<b>Subject:</b>  FUEL FILLER LID DOES NOT OPEN OR CLOSE	<b>Bulletin No:</b> 09-029/15
	<b>Last Issued:</b> 08/04/2015

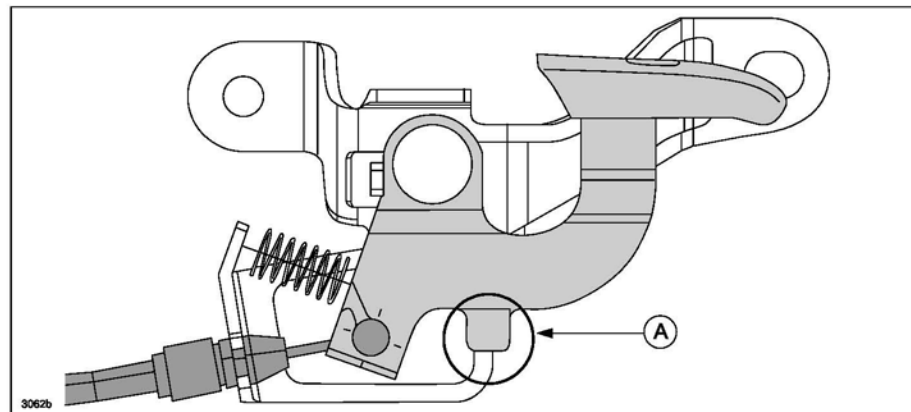
On some vehicles, the fuel filler lid will not open/close. This may be caused by snow with road salt being brought into the footwell area. The melted salt water then flows along the opener lever (A) and enters into the cable (B) causing the inner-cable to corrode and seize.

To correct the problem, a flange has been added to the fuel filler lid opener lever (A) to prevent water from flowing along the lever to the fuel filler lid cable.
